UNITED STATES PATENT AND TRADEMARK OFFICE

APPLICATION NO.	FILING DATE	FIRST NAMED INVENTOR	ATTORNEY DOCKET NO.	CONFIRMATION NO.
09/476,521	01/03/2000	Herbert Gropp	RUM212	7964
7590	06/30/2004		EXAMINER	
Horst M. Kasper 13 Forest Drive Warren, NJ 07059			LUONG, VINH	
			ART UNIT	PAPER NUMBER
			3682

Office Action Summary

ATTACHMENT

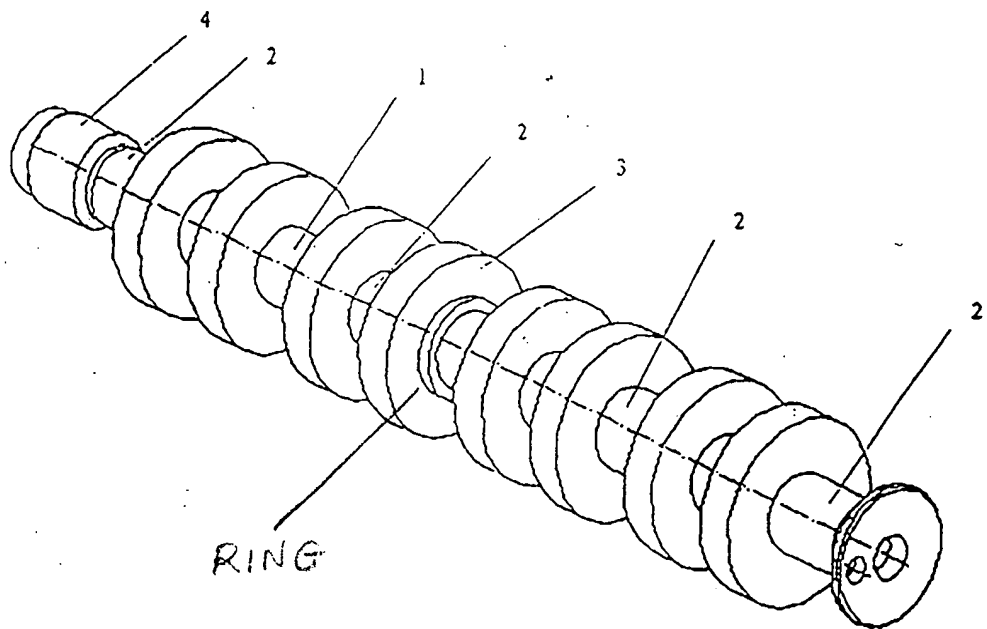
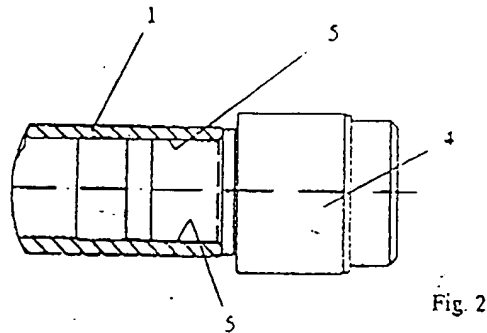
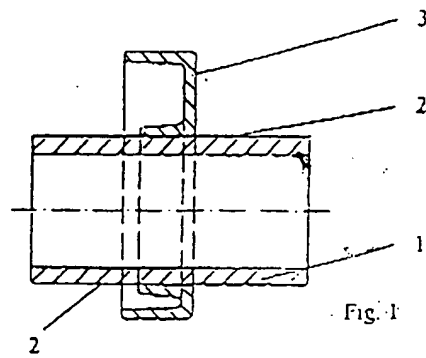
(b) New Fig. 3 introduces new matter, such as, the deletion of a ring (unnumbered, see Attachment attached). The original Fig. 3 shows the ring located adjacent to the cam 3, however, new Fig. 3 now does not show such ring. See *Twin Disc v. United States*, 231 USPQ 417, 435 (US Cls. Ct. 1986)(new matter by deletion).
